Heavy Commercial Vehicles

Subject	Intarder Cooling System, replacement of metal pipes
Variant	All vehicles that have intarder
Abstract	This technical bulletin describes the transition to installation design with an O-clip in order to prevent bracket problems caused by metal pipes in the Ford Trucks Intarder Cooling System

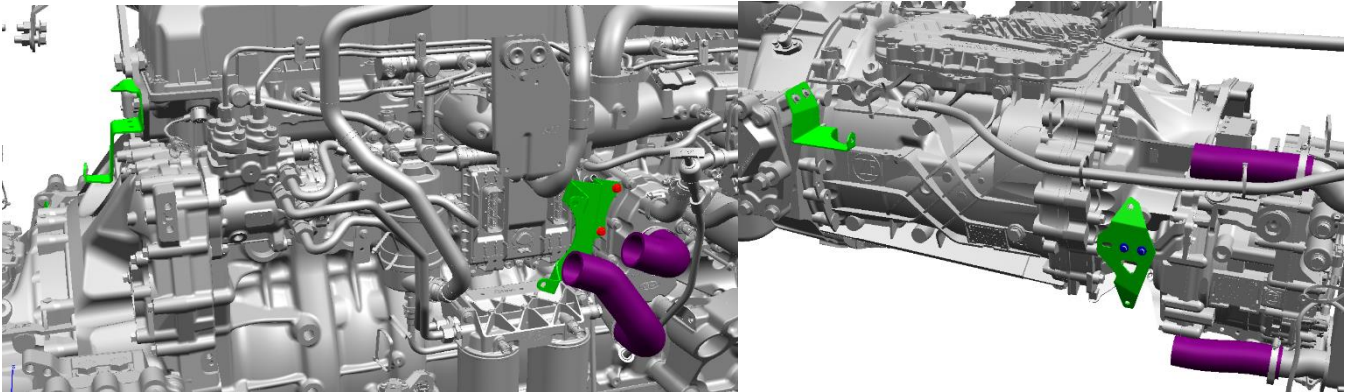
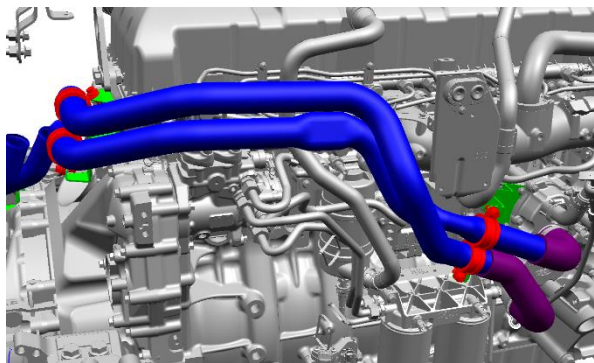
Install new bracket to their positions and complete the tightening of bolts to the specified torque values.

25±3.8 Nm

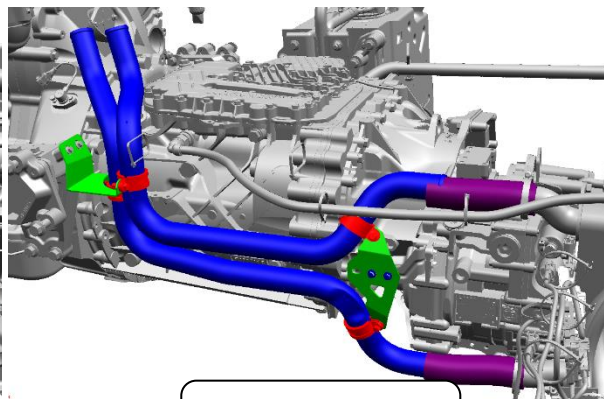
Place new metal pipes to their positions and position the O-clips between the markings. Then, tighten the bolts to the specified torque values.

$25 \pm 3,8$ Nm

$47,5 \pm 7,2$ Nm

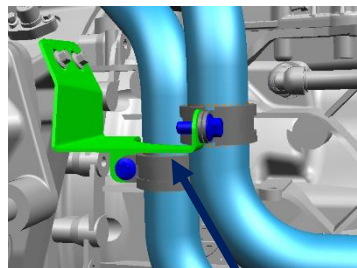
O-Clip: LC46-721488-AA x

O-Clip: DC46-721488-AA x

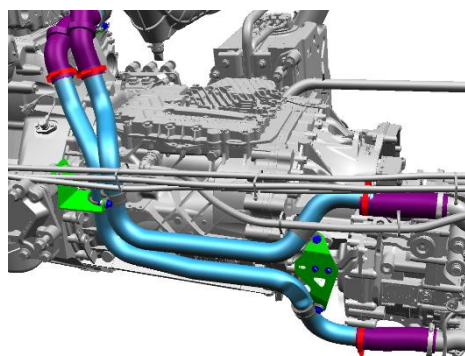
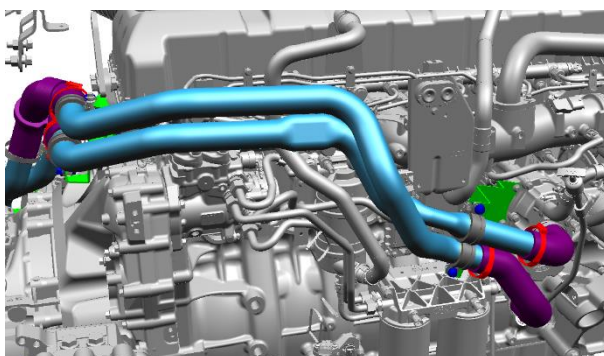
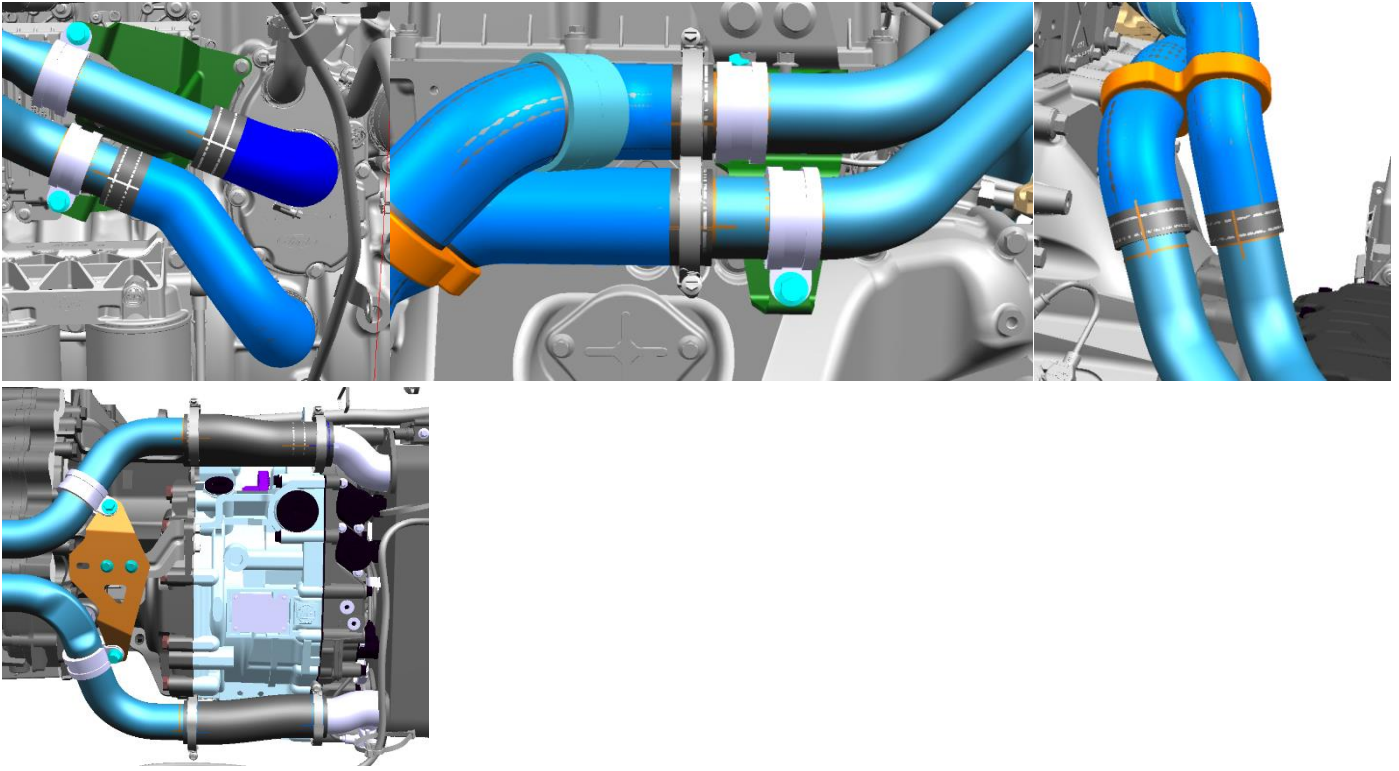
Insert hoses to metal pipes and position as per the aligning lines. Then, tighten the clamps and complete the operation.

5.4 ± 0.5 Nm
